- MAJOR DESIGN CHANGES FOR RC-05 -

DATE: October 13, 2008

Figure 1: RC-05 (OLD)

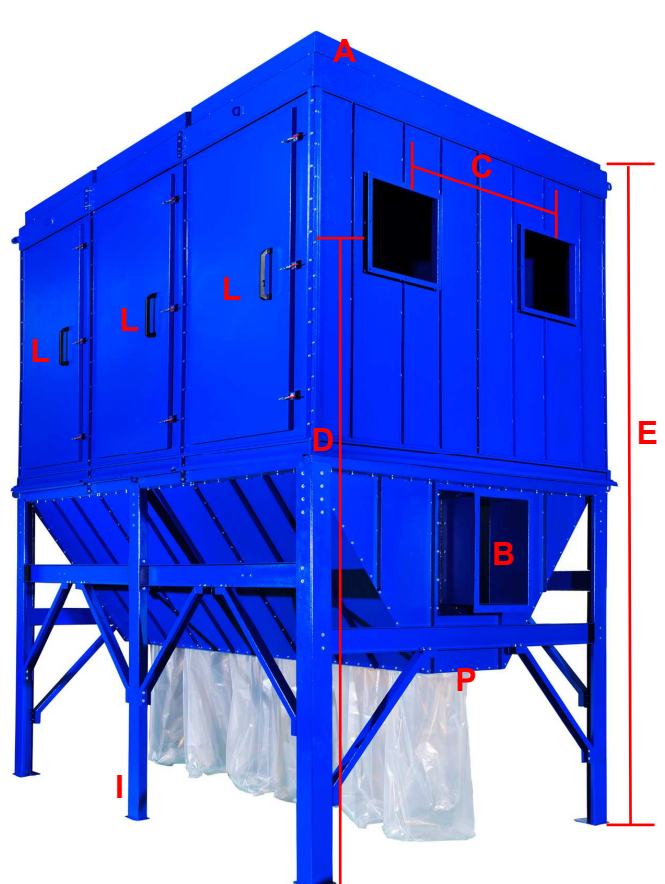
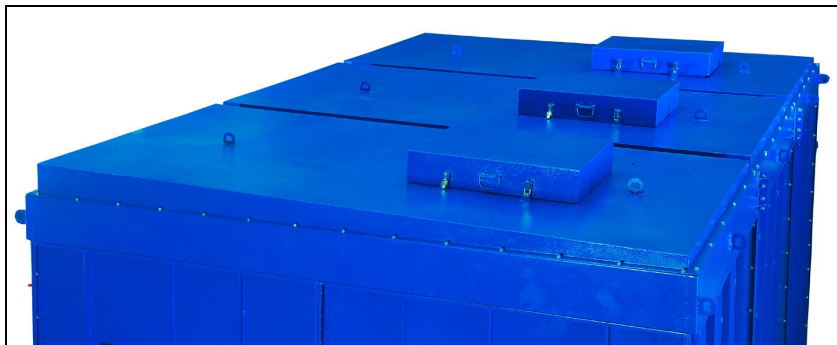
A) Height of the Upper Lid has been amended from 105mm to 150mm (6")

B) Height of the Hopper Inlet is 2064mm / 81.26" (match)

C) Distance of the two Outlet is 1485mm / 58.46" (match)

D) Outlet height is 4196.5mm / 165.2" (match)

E) Overall machine height is 5330.8mm / 209.87"

F) Same Inlet to Hopper from the ground (side) 2826mm / 111.26" (match)

G) Same Inlet to Hopper from the ground (front) 4317.2mm / 170" (match)

H) Distance of the Inlet Connector 323.4mm / 12.7" (match)

I) Increase Middle Pillar

- J) Inlet Flange (match)
- K) Outlet Flange (match)
- L) Maintenance doors are bolted with hinges and fast clamp to avoid falling off
- M) The stand is more durable and heavy duty (like SDC-28500 for Altec)
- N) The unit is easier to assemble (takes approximately 4 men in two days to assemble the unit plus silicon sealing)
- O) Frames are welded to ensure sealing
- P) New Spring Clamps for clipping the plastic bags.
